Discretionary Review Abbreviated Analysis

Date: August 28, 2014 Case No.: **2014.0529D**

Project Address: **3984 20**TH **STREET**Permit Application: 2013.07.09.1387

Recommendation: Do not take DR and approve as proposed

Photo #1 Lightwell

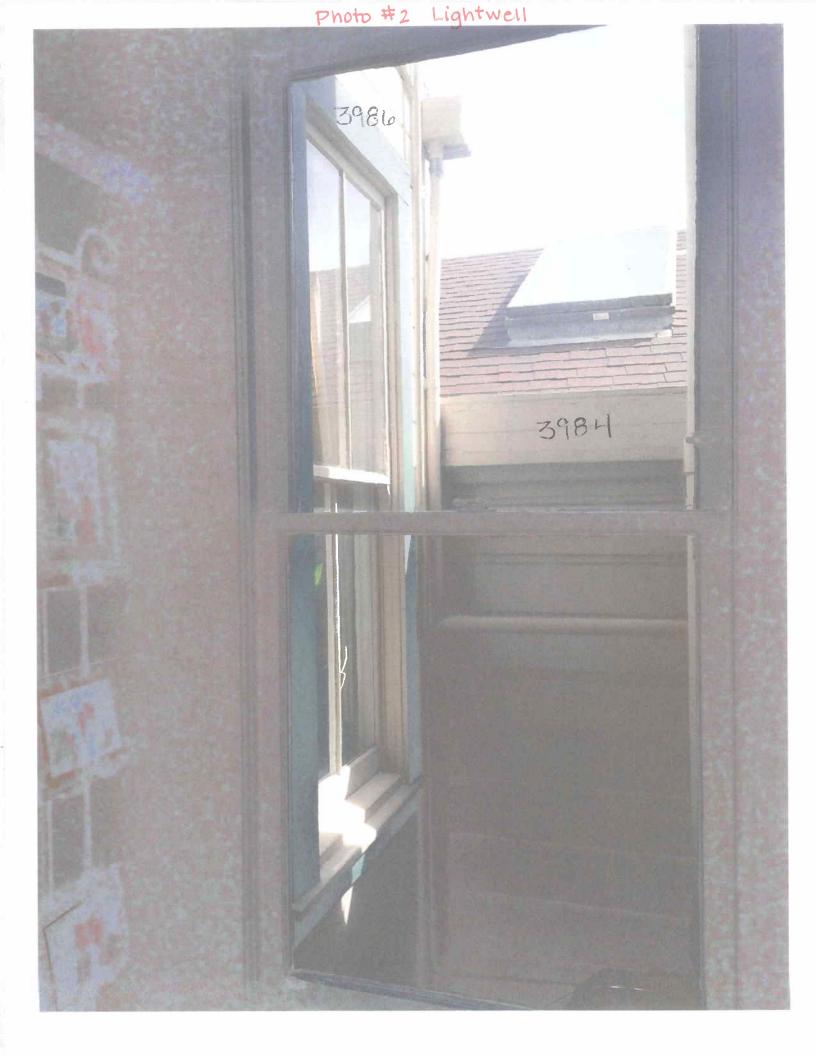
We understand that some impact is an expected part of construction, however we stand to be severely impacted. We currently have 9 windows on the west side of our house, most of which only let in a limited amount of light due to the height of the adjacent property. The majority of light and heat enters our house from the east side windows and the light well (photo #1 & 2) in the center east side of the house. Our light well is the single source of daylight to the laundry room (photo #3), and middle floor bathroom (photo #4). It is also

Photo # 6 Interior Hallway

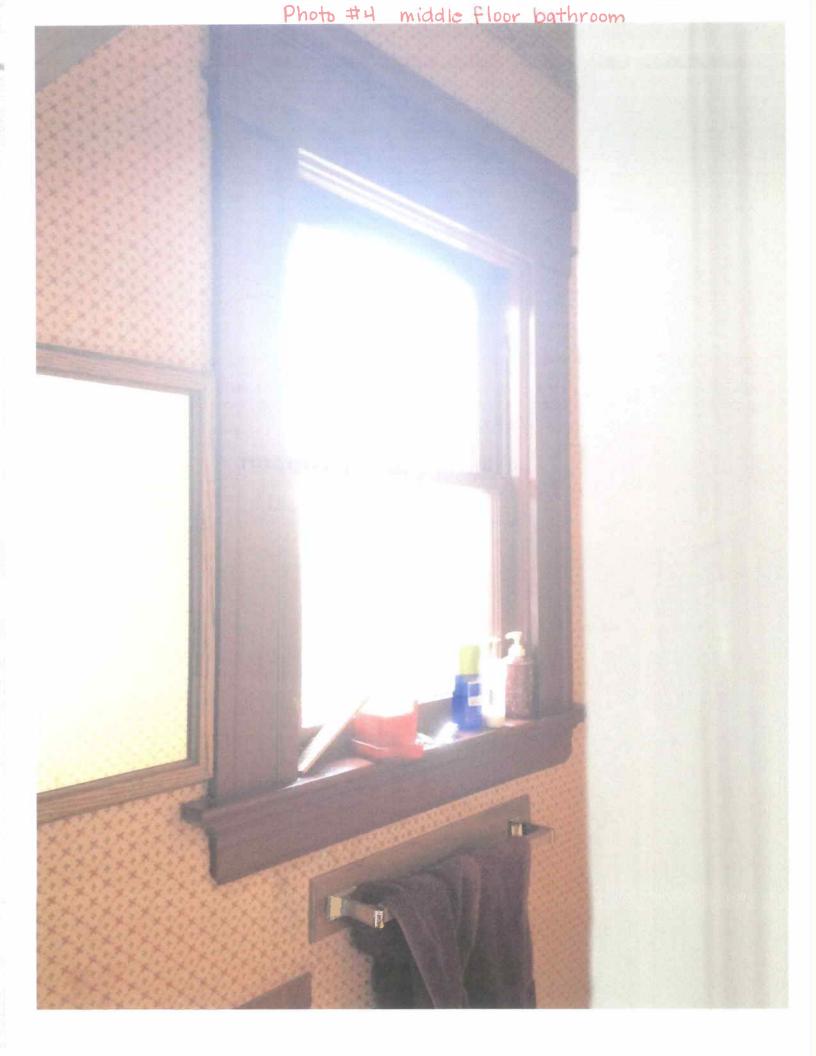
a major contributor to the daylight in the bottom floor family room (photo #5), the interior hallway (photo #6 & 7), and the dining room (photos #8 & 9).

D.R. Requester's Lightwell - Photographs

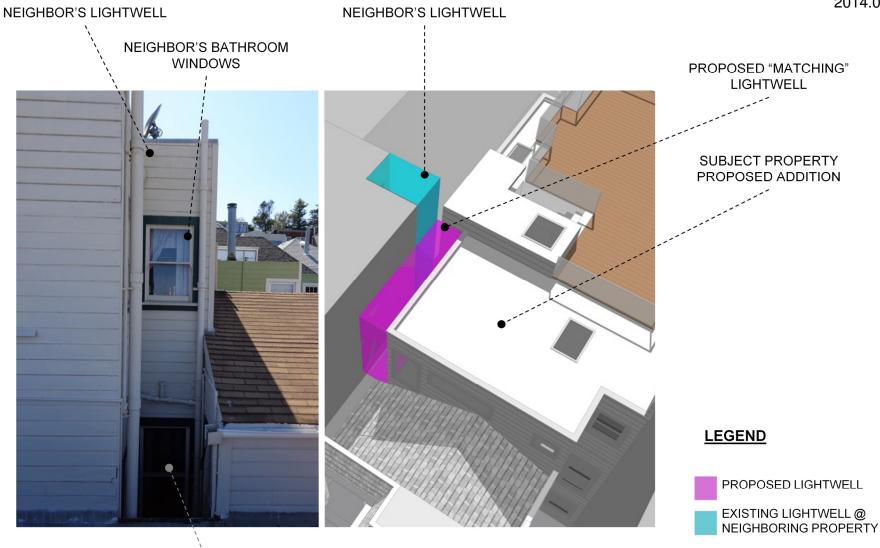
We are requesting Discretionary Review because we believe that this project causes significant loss of light, air, view and privacy, severely impacting our home which is adjacent to the proposed project. When the variance was granted to the previous owners under the city planning code case no. 92.606V it was decided that "No further vertical or horizontal expansion of the subject building shall be allowed unless such expansion is specifically authorized by the Zoning Administrator after the property owner or authorized agent has sought

This project would dramatically effect 12 western windows, some of which would be completely devoid of light, and will negatively impact our lifestyle. It will change the way we feel about our living space and our time spent at home. Not only does this natural light create a better ambiance, but it reduces our energy consumption and our energy costs.

Lightwell windows primarily serve bathrooms and hallway

West Property Line Condition

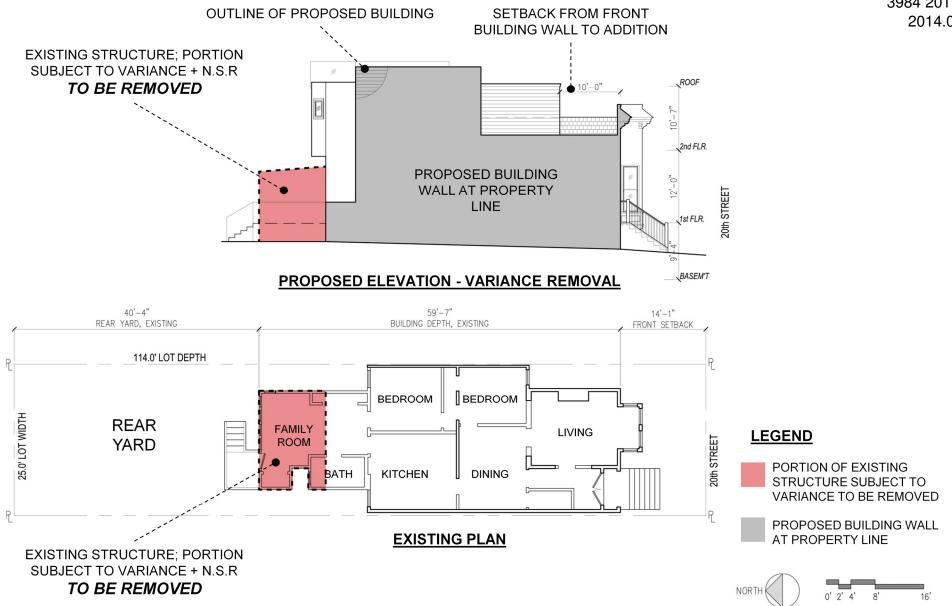
The Requestor does not cite any exceptional or extraordinary circumstances, and so does not suggest any changes that would reduce those unspecified circumstances. His concerns center on the loss of light to his light court windows, which we have helped by providing a voluntary side setback on the new upper story. Reduction of light to the Requestor's hallway, bathroom and stair well will be minimal, and the dining room has another window with a perpendicular orientation to provide light. Air will not be noticeably affected by this addition.

- We voluntarily adjusted proposed floor plan to accommodate D.R. Requester's property line windows.
- Proposed lightcourt opens to front of building
- Our proposed lightcourt greatly exceeds size required by Residential Design Guidelines
